**U.S. ENVIRONMENTAL PROTECTION AGENCY
REGION III WATER BRANCH, ENFORCEMENT
AND COMPLIANCE ASSURANCE DIVISION
CLEAN WATER ACT
COMPLIANCE INSPECTION REPORT**

Name of Facility: East Manchester Township MS4
Facility Address: 5080 North Sherman Street Ext, Mt. Wolf, PA 17347
Mailing Address: 5080 North Sherman Street Ext, Mt. Wolf, PA 17347

Report Prepared on: 3/3/2021
Date

Photograph 4. View of the outlet for the new stormwater pond. Note that sediment was observed at the outlet.

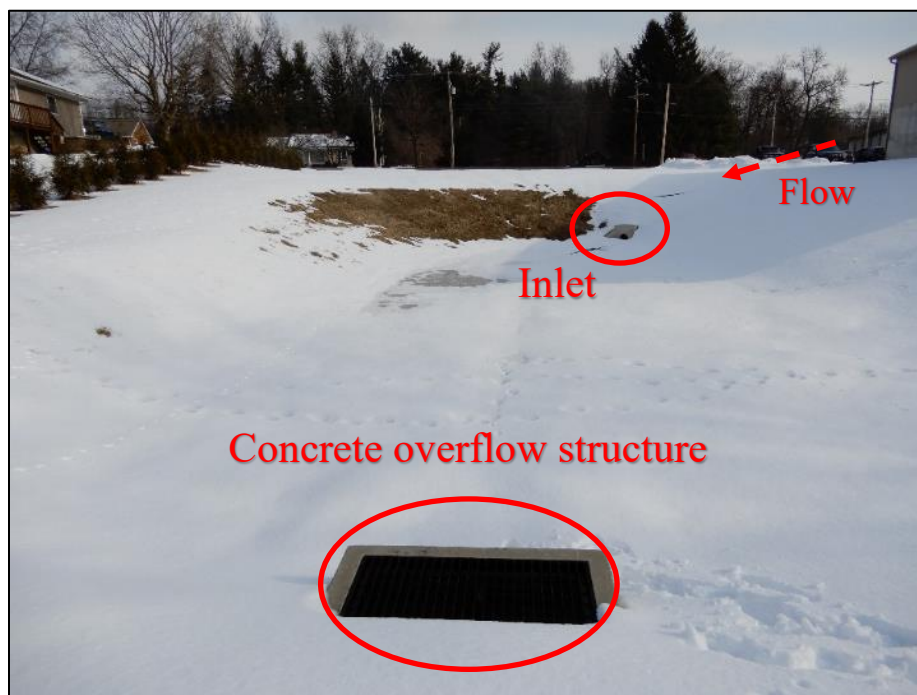
- 3) Township staff stated that during construction of the parking lot, the stormwater pond was used as a sediment trap. According to Township staff, the project has not been officially closed, and an underdrain still needs to be installed in the pond. This is shown on the new construction drainage plans (refer to Appendix B, Exhibit 1). Some sediment was observed at the outfall of the new stormwater pond during the inspection (refer to Photograph 4).

Photograph 5. View, facing southeast, of the used oil storage tank located on the western side of the property. The tank had a volume of approximately 150 gallons; it was not double-walled or located within secondary containment.

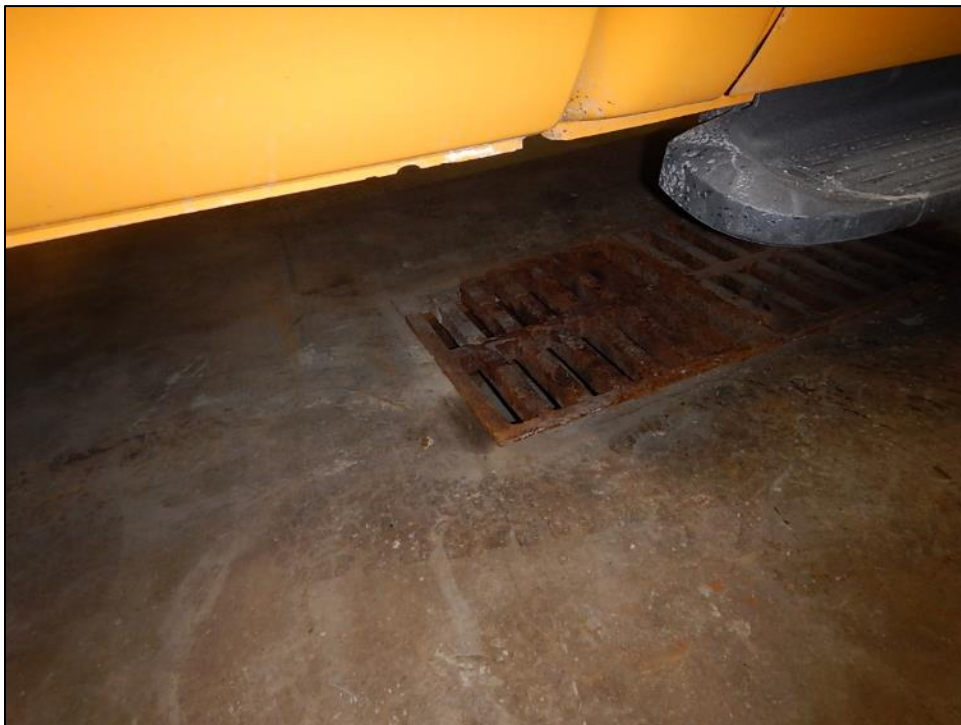
- 4) The EPA Inspection Team observed a used oil tank without secondary containment on the west side of the Maintenance Building (refer to Photograph 5). Township staff stated that the tank is single-walled and that the oil is disposed of very infrequently, every 2-3 years.

Photograph 27. View, facing west, of the outlet structure. Note that the concrete channel is not visible due to the vegetation growing in the accumulated mud and sediment in front of the structure. Litter was also present near the outlet.

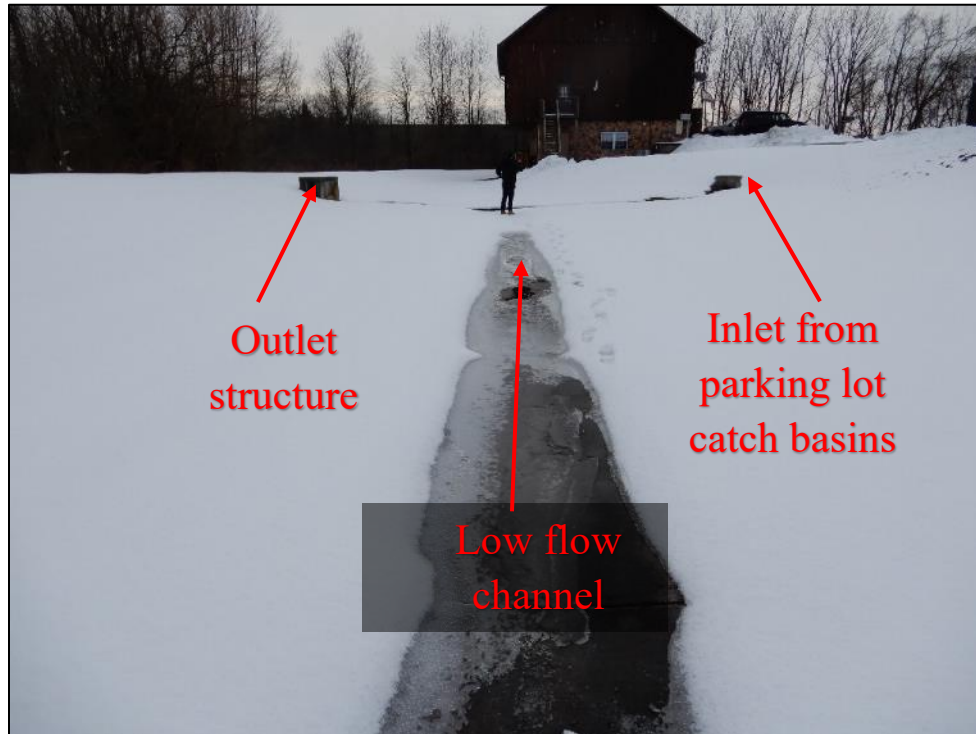
- 3) The EPA Inspection Team observed litter in front of the outlet and inlet structures as well as at the outfall into the wetland area (refer to Photographs 27 through 29). Litter in the basin was also referenced in the May 2019 inspection report (refer to Appendix B, Exhibit 6).

- 4) Mud and sediment with vegetation growing in it was observed to be accumulated in front of the outlet structure. Township staff stated that the concrete low flow channel extended to meet the outlet structure. Vegetation at the outlet was also referenced in the May 2019 inspection report (refer to Appendix B, Exhibit 6).

Photograph 40. View inside the concrete riser outlet structure. Note the rocks and sediment inside the structure.

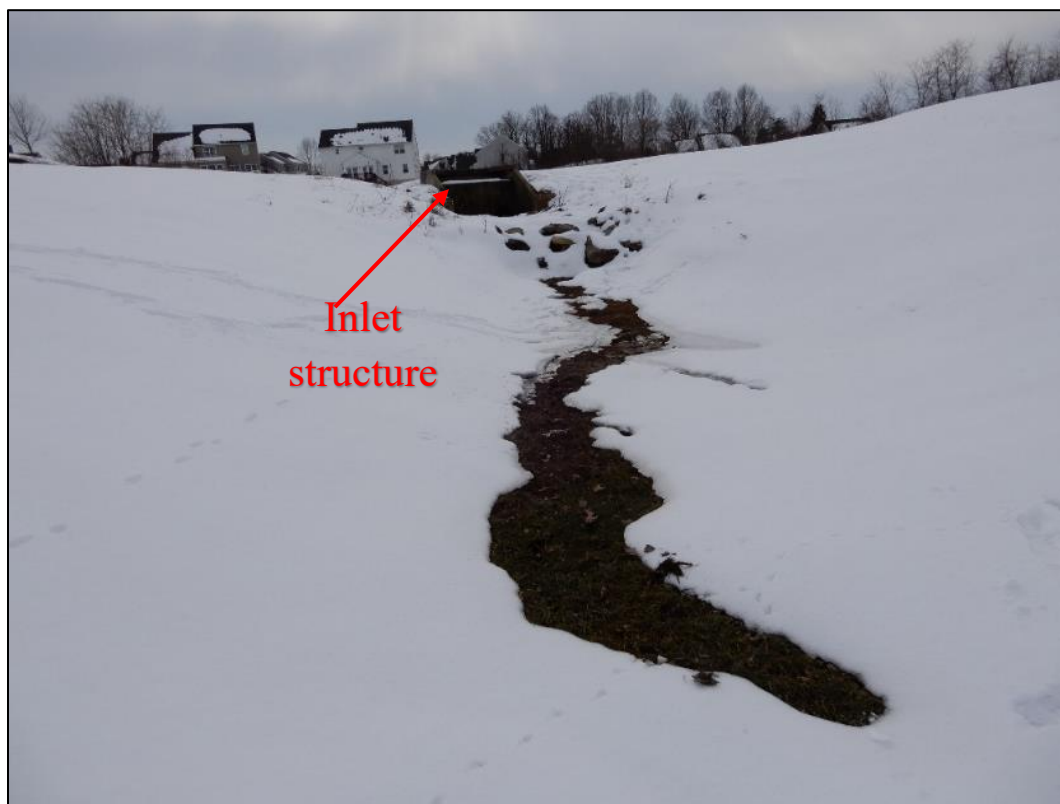
- 3) The EPA Inspection Team observed rocks and sediment inside the concrete riser outlet structure (refer to Photographs 39 and 40).
- 4) The EPA Inspection Team observed signs of erosion at the center of the stormwater basin (refer to Photographs 41 and 42).
